**LAND USE DIVISION INTEROFFICE MEMORANDUM**

**RE: SUBDIVISION REQUIREMENTS - IN THE MATTER OF THE VALADAO, APPLICATION # PLN-2021-17560 FMS, APN 510-381-021, FOR APPROVAL OF A TENTATIVE MAP, CONSISTING OF 2.47 ACRES INTO 17 LOTS**

**DATE: 01/09/2023**  
**10/25/2023 revised TM**

**These recommendations are based on the revised tentative map prepared by Kelly-O’Hern dated April 2023, revised May 10, 2023 and received electronically by the Humboldt County Planning Division on September 29, 2023.**

*Above: Typical section for widening Pickett Road*

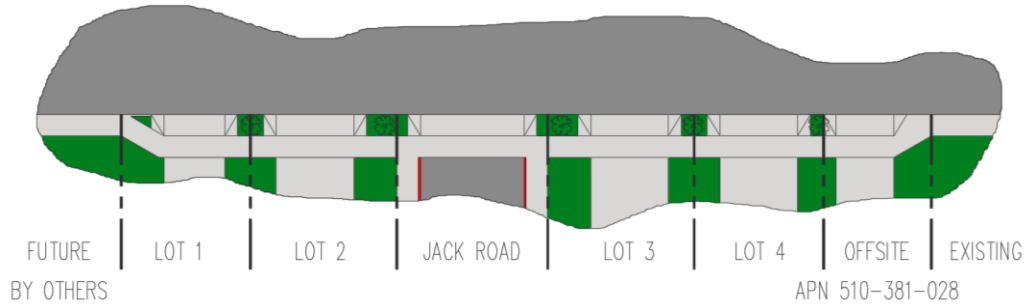
- (a) **Pickett Road (County Road No. 4M030)** shall be constructed having a typical section comprised of two 12 foot wide driving lanes, an 8 foot wide parking lane, a 5' wide landscape strip (4.5' wide useable) and 5' wide pedestrian sidewalk with Caltrans Type A2-6 portland cement concrete (PCC) curb and gutter fronting the subject parcel.

*Above: Plan view of Pickett Road widening and Jack Road intersection. Alternatively, driveways for Lot 1&2 and Lot 3&4 may be combined.*

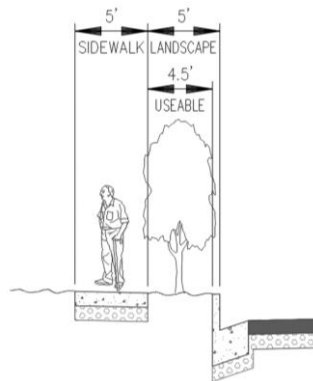
- (a) A stop sign shall be installed on Jack Way at its intersection with Pickett Road. A stop sign shall be installed on Jack Way at its intersection with Gwin Road. When the road is paved, a "stop" pavement marking and limit line shall be installed.

At its intersection with Pickett Road and at its intersection with Gwin Road, construct Urban Dwy No. 1.

*Above: Typical section for widening Gwin Road*

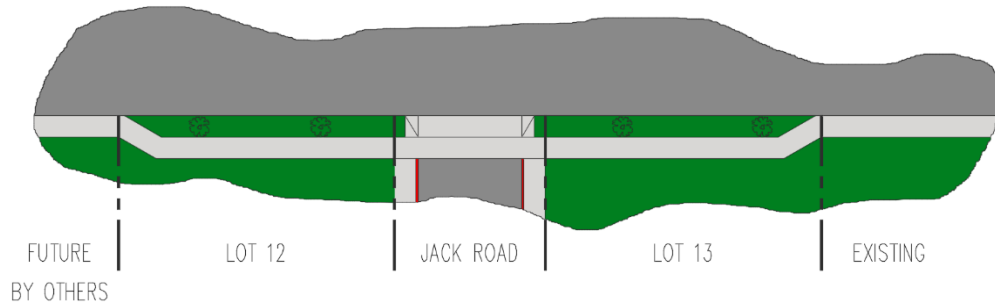
- (b) **Pickett Road (County Road No. 4M030) OFFSITE:** construct in fill curb, gutter, sidewalk, and urban driveway No. 1 across the frontage of APN 510-381-028. (This was the former access to the subject property.)
- (c) **Gwin Road** shall be constructed having a typical section comprised of two 12 foot wide driving lanes, an 8 foot wide parking lane, a 5' wide landscape strip (4.5' wide useable) and 5' wide pedestrian sidewalk with Caltrans Type A2-6 portland cement concrete (PCC) curb and gutter fronting the subject parcel.

Above: Typical section for Jack Road

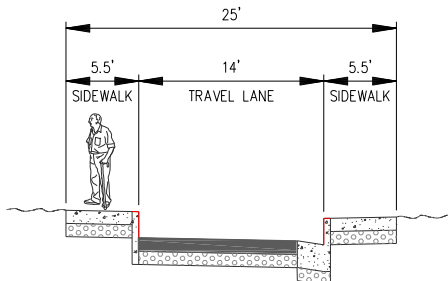
- (d) **Jack Way** shall be constructed 24' in width with a 3' wide concrete valley gutter in the center of the roadway. A 5' wide sidewalk shall be provided along both sides of the road. Where parking stalls are provided, the road shall have a 16' deep parking stall with Caltrans Type A1-6 curb and 7 foot wide sidewalk.

Parking stalls shall be a minimum of 9 feet wide in order to utilize a 24 foot wide roadway. A wider roadway is necessary if narrower parking stalls are desired.

The road is not designed for on-street parallel parking. In all areas where perpendicular parking is not provided, the curb shall be painted red or otherwise posted for no parking.

*Above: Diagram showing landscape medians where perpendicular parking is provided.*

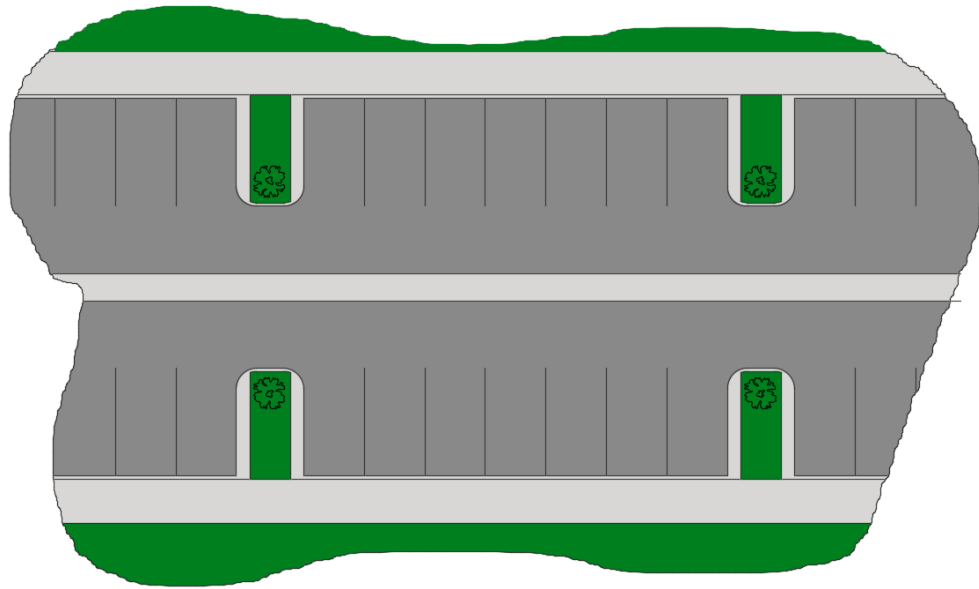
Where perpendicular parking is provided, provide landscaped medians periodically, roughly at each lot line
